Tamishna Fashion Wear Ltd (new building)

Plot # 247, Bhadam, Nishatnagar, Tongi, Gazipur
(23.898755, 90.358666)
8th July 2019

Discrepancies in as-built drawing

Column Layout

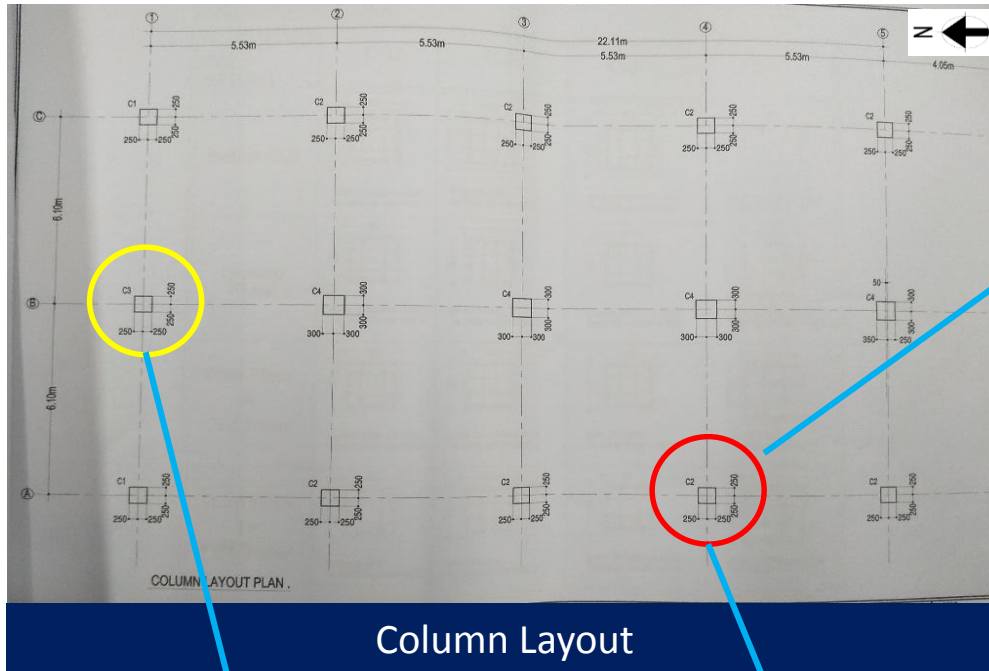
Number of rebar in C-3 and C-2 type column didn't match with column schedule. In C-3 column 4 rebars were counted by ferro scanning in one direction instead of 6 rebars. In C-2 column 5 rebars were counted by ferro scanning in one direction instead of 7 rebars.
